# Preliminary Design Review Report - Revision 2

Woodside Care Precinct Upgrade

May 2022

At the request of Donald Cant Watts Corke/Hall & Prior, Arbor Centre has been engaged to undertake an Arboricultural design review of proposed landscape and preliminary construction design for Woodside Care Precinct Site. This report has been commissioned to investigate how the trees identified for retention may cope with the proposed design and works associated with construction of the proposed buildings and proposed Basement alignments. This Design Review process considers alternative design options, and/or works methodologies, that may be applied to avoid (where possible) and minimise (where unavoidable), project related impacts and allow modification (where approved) to the Tree Protection Zones (TPZs) for the trees identified for retention.

Figure 2. Hassell Drawing 'Tree Species' Woodside Health Care Precinct. Image Source Hassell Studio

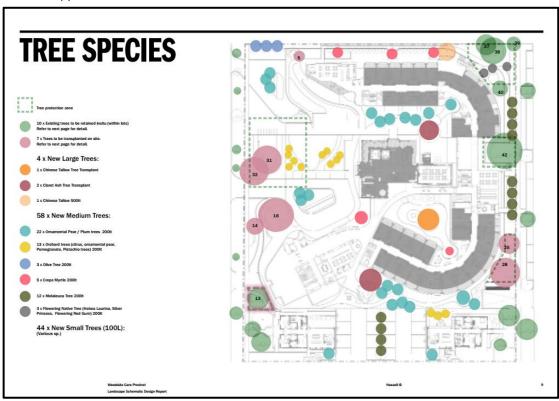
The breakdown of tree requirements for the site is as follows (refer figure 2 for detail):-

- Trees to be retained and protected (outlined green) and include tree numbers:
  - o 13, 42, 40, 37, 39, 38, & Various Verge Street Trees (Fortescue and Dalgety Streets)
- Trees To be transplanted (from within the Site) (highlighted Pink) and include tree numbers:
  - o 32, 31, 5, 14, 25, 16, & 28 refer Arbor Centre 'Preliminary Tree Transplant and Relocation Considerations Report' for further detail
- Trees To be Removed and include;
  - 303, 302, 9, 15, 27, 18, 19, 1210, 2111, 1154, 1155, 1156, 22, 21, 20, 3, 4, 180, 2241, 2208, 2210, 17, 49, 44, 2211, 2213, 43, 30, 29, 5021,35, 1, 2, 10, 33, 6, 34, 11, 12, 24 & Various Trees in rear of 26 Dalgety Street and 29 Fortescue Street
